date: February 20, 2025
to: James Murphy, Assistant Director of Planning and
Zoning, Town of Palm Beach
from: Eric Czerniejewski, P.E., ENV SP
subject: 2720-2730 South Ocean Blvd Traffic Review

MEMORANDUM

The Corradino Group, Inc (Corradino) has been requested to provide a traffic review of the Traffic Impact Analysis and Parking Evaluation for the redevelopment of the two properties located at 2720 to 2730 South Ocean Boulevard, Palm Beach, Florida. The following are our traffic review comments based on the 01/28/25 resubmittal.

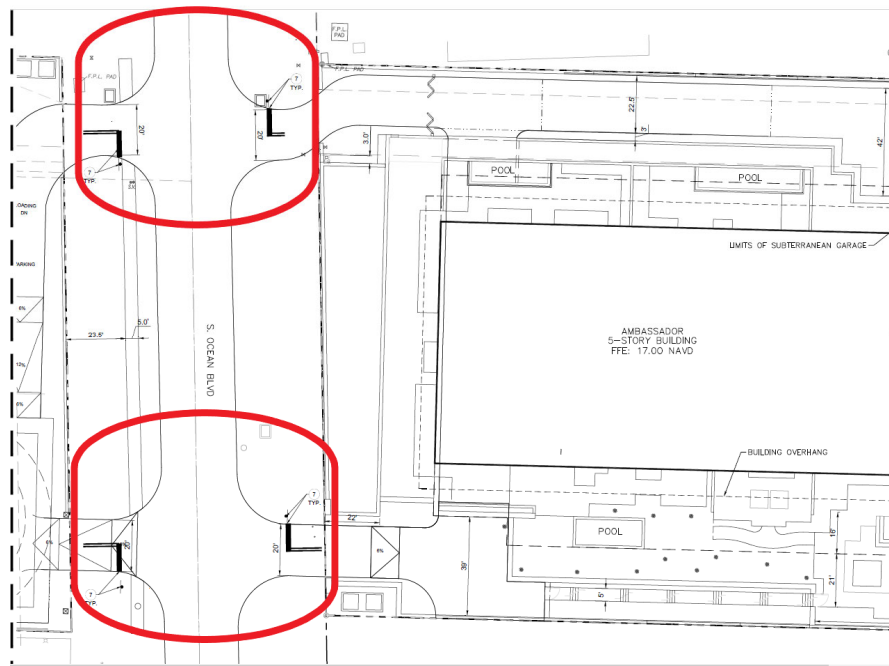
2. Please provide a copy of the FDOT pre-application meeting letter that resulted from the pre-application meeting held on 05/23/24. This letter should provide for any conditions related to the planned site access connections to State Road A1A/South Ocean Boulevard.

Kimley Horn and Associates, Inc.'s 12/26/24 Response: Applicant is continuing to coordinate with FDOT on the issuance of the letter and it will be provided upon receipt.

TCG 02/20/25 Response: This item is still pending. Please send letter when available.

Figure 212.11.1 Clear Sight Triangles

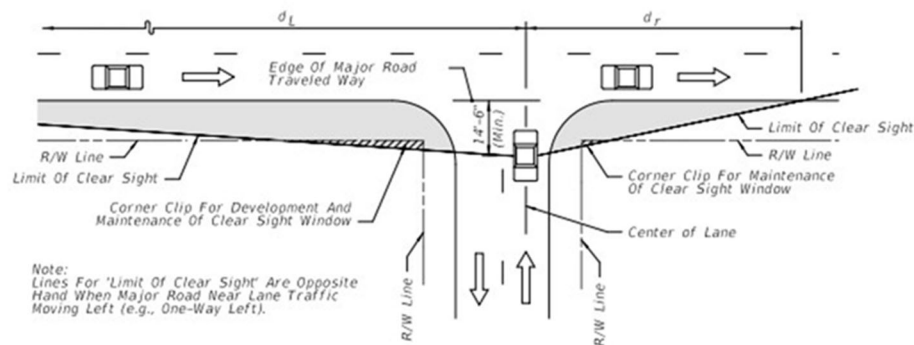
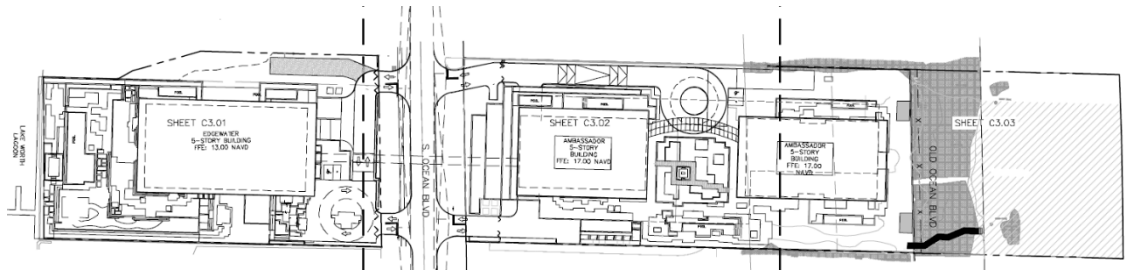
5. Please provide sight visibility triangles on the site plan at each of the driveway connections to State Road A1A/South Ocean Boulevard. The sight triangles should also be depicted on the landscape plans and the pavement marking and signage plan. The sight triangles along State Road A1A/South Ocean Boulevard should meet FDOT criteria as outlined in the FDOT Design Manual (Section 212.11).

Kimley Horn and Associates, Inc.'s 12/26/24 Response: The updated plans now include sight visibility triangles.

TCG 02/20/25 Response: Addressed.

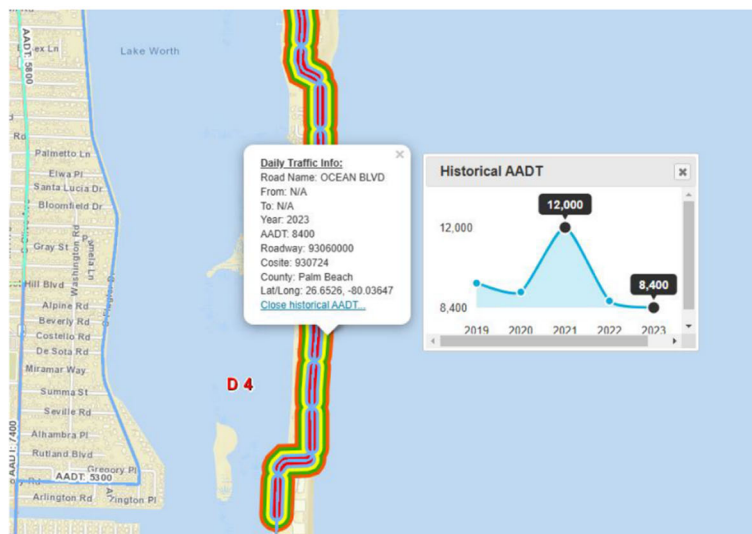
7. Please confirm if valet parking will be provided for the proposed residential use. Please provide a valet parking analysis if valet parking is going to be provided.

Kimley Horn and Associates, Inc.'s 12/26/24 Response: A valet evaluation is included in the updated analysis.

TCG 02/20/25 Response: Addressed. Please see comment #10.
